WRONG!!!

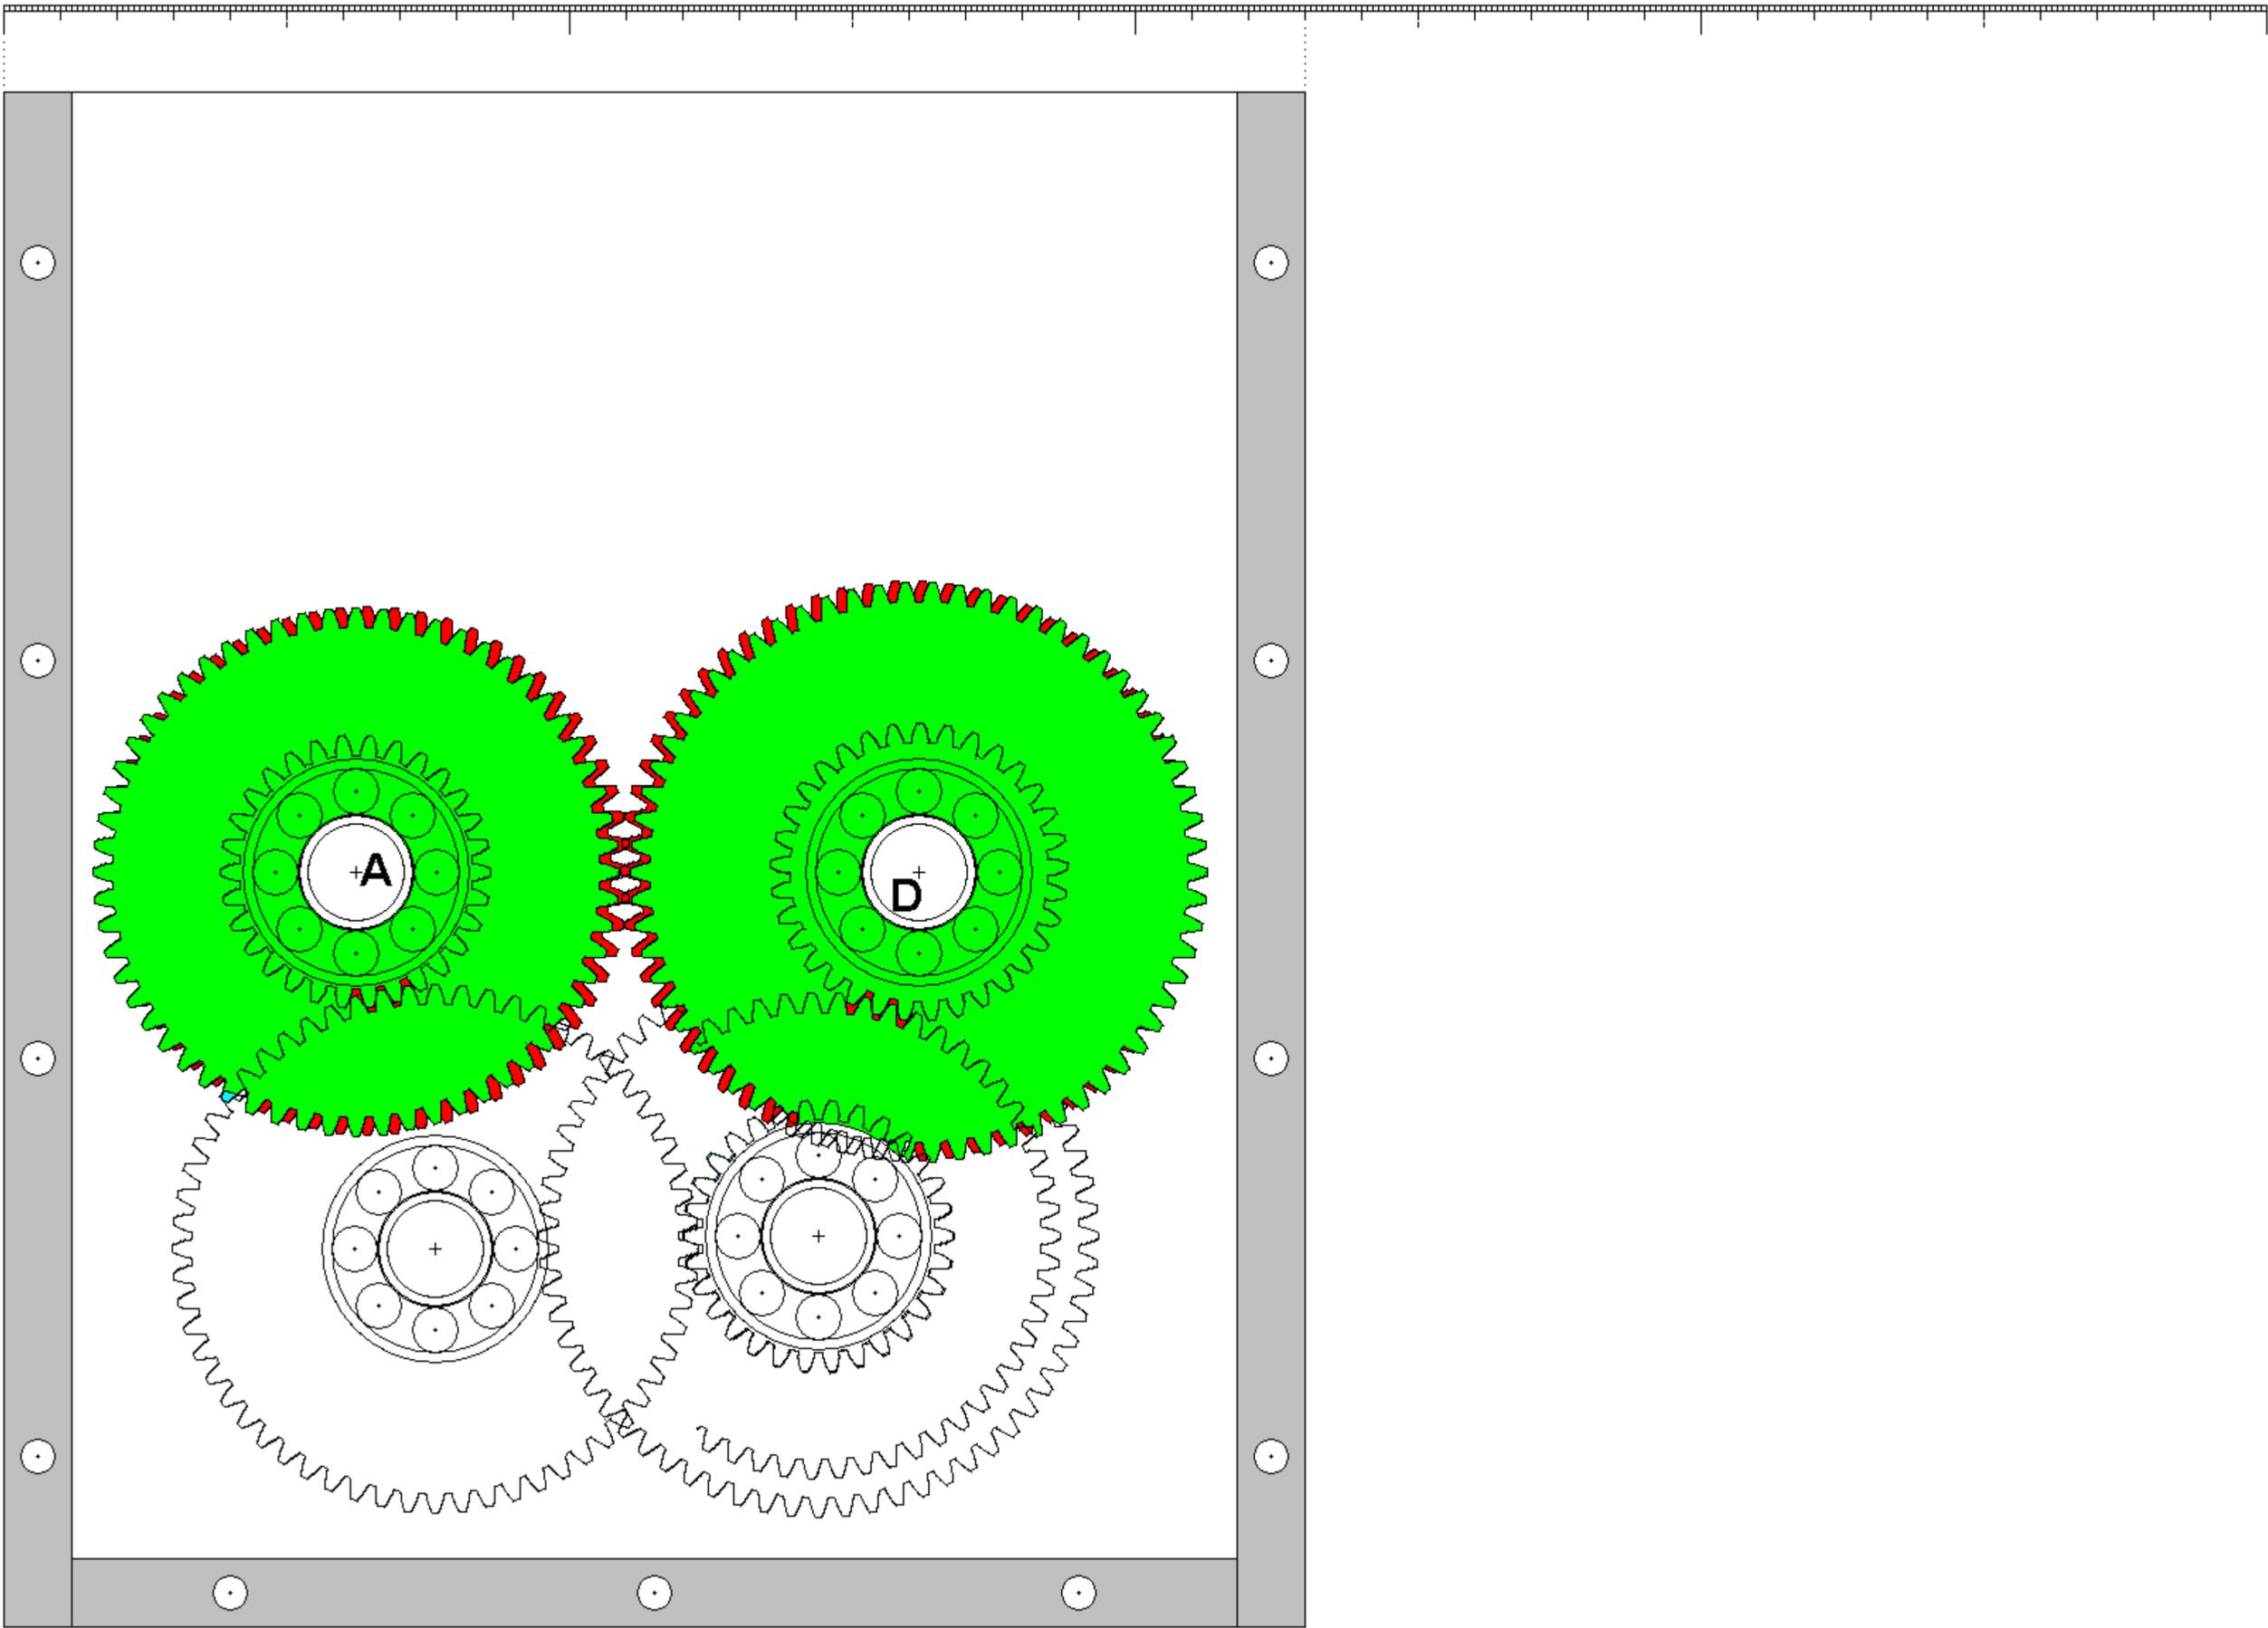
Shafts A and B should be positioned more apart than in this drawing, as 60 teeth gear can come in contact with 66 teeth gear. This can happen only while shifting gears, not when gears are engaged and running.

CORRECTED!!!

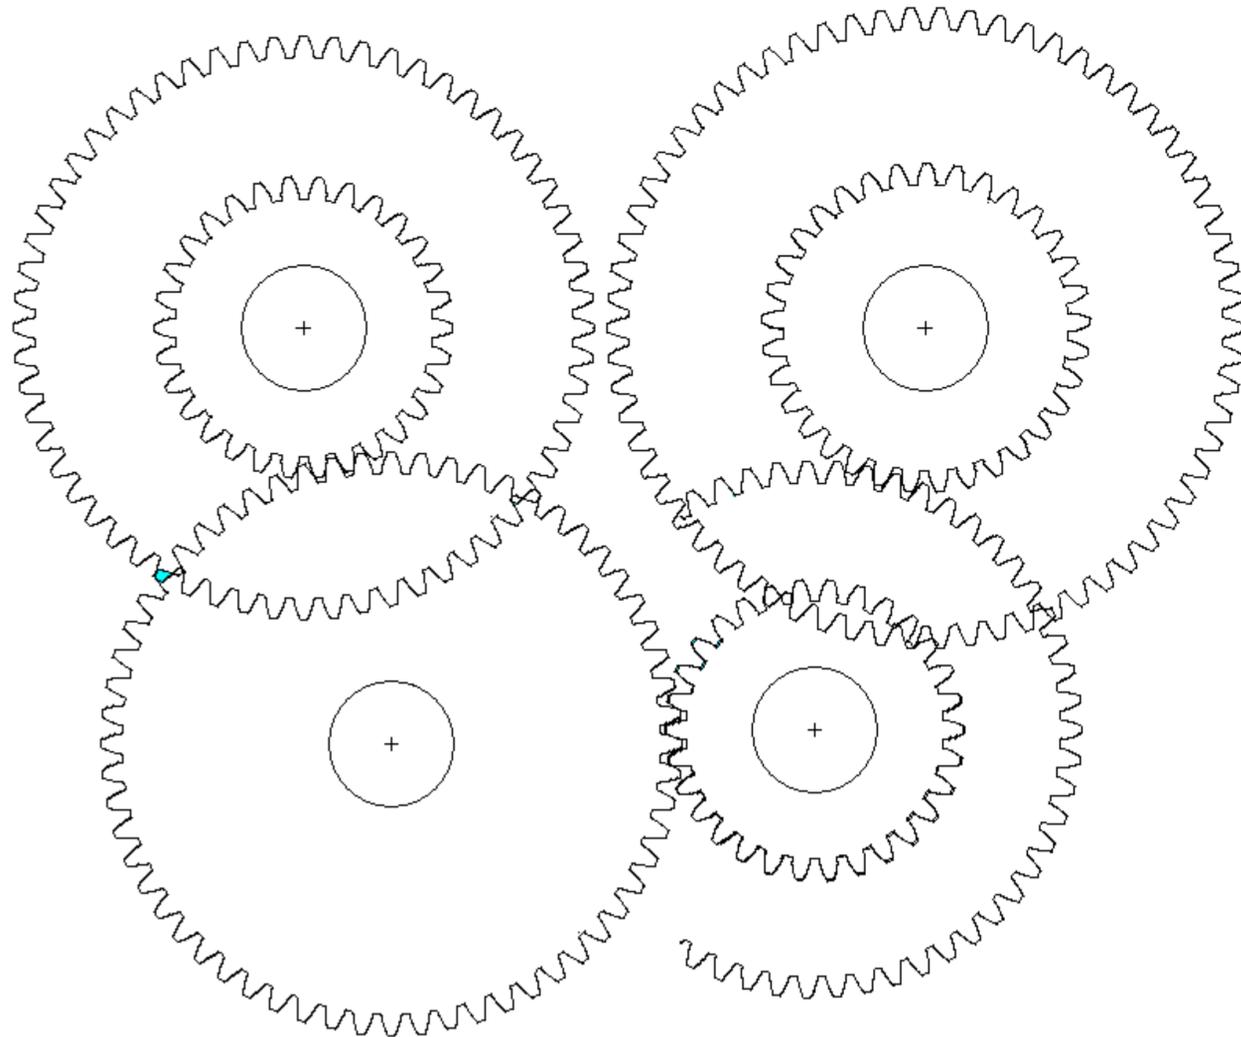
CORRECT DIMENSIONS

USE THIS ONE.
